| Project | IEEE 802.16 Broadband Wireless Access Working Group < http://ieee802.org/16 > | |
| Title | Clarification of renumbering and permutation based on DL_PermBase parameter | |
| Re: | IEEE 802.16 WG Recirculation Ballot #17a on P802.16-2004/Cor1/D2 | |

Replace Figure 219 with the following figure:

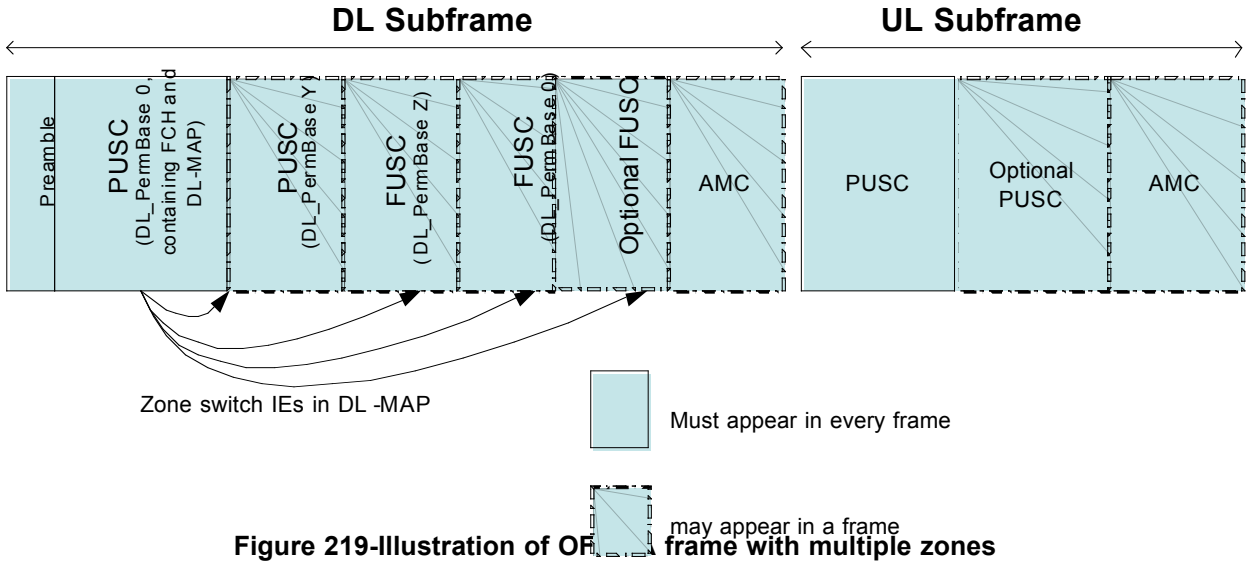
[The DL_PermBase = 0 in the first zone which includes FCH and DL MAP. It's better to indicate that IDcell = X in the figure after Preamble.]
